## Network Camera Firmware Version: V5.7.101

### Release Note

<b>Firmware</b> <b>Basic Information</b>	Firmware Version: V5.7.101 build 221206
---	---

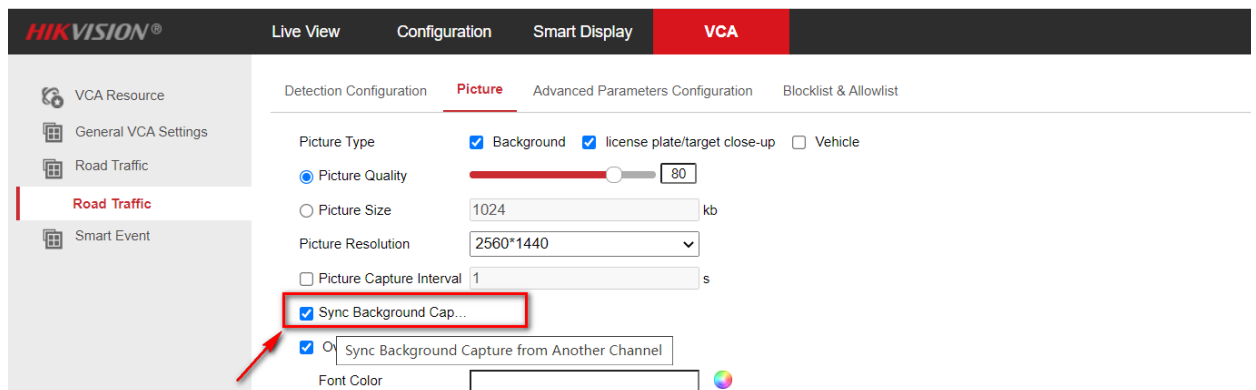
- Support road traffic alarm linkage camera 2 capture function. Enter VCA- Road Traffic- Picture-, enable Sync Background Capture from Another Channel.

Note: The interval of camera 2 is 1s. If the alarm of the road traffic triggers multiple alarms within 1s, will generate same capture for these alarms.
